Agenda
Village of Glen Ellyn
Plan Commission
Regular Meeting
Thursday, January 24, 2019
7:00 PM

- D. Public Hearing - 495-499 Roosevelt Road - Raising Cane's Chicken Fingers - Special Use Permit, Zoning Variations, & Sign Variations**
 - 1. Public hearing with discussion, consideration, and recommendation regarding a request for approval of a Special Use Permit, Zoning Variations, and Sign Variations for Raising Cane's Restaurants, LLC to construct a 3,707 square foot Raising Cane's Chicken Fingers restaurant with a drive-thru. The subject property is located at the southwest corner of Main Street and Roosevelt Road, commonly known as 495-499 Roosevelt Road, in the C3 Service Commercial District (Planning Intern Clements)

- E. Pre-application Meeting - 21W536 Acorn Avenue & 0N282 Cumnor Avenue - Crane & Anest - Minor Subdivision with Subdivision & Zoning Variations**
 - 1. 21W536 Acorn Avenue & 0N282 Cumnor Avenue – A pre-application meeting to discuss the Minor Subdivision of these two lots into three lots with variations (Planner Purvis)

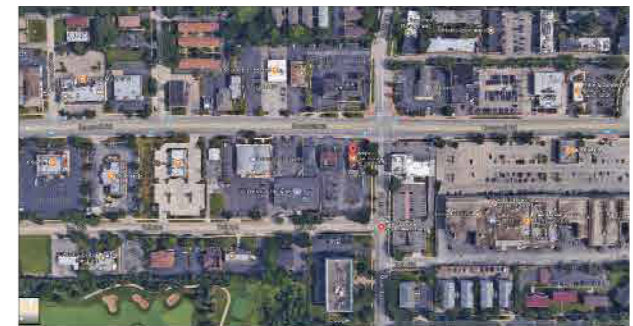
No MSP/PUD noted during check	BLUE DOG	MUR
Only allowed 1 wall sign per street front, max 3 signs (150 SF)		
Mural can't be painted		
Neon/LED border and flags are not allowed	YES	☐
Art is subject to approval	NO	☒
Variations require physical hardships per city		
Village will not allow mural or blue dog
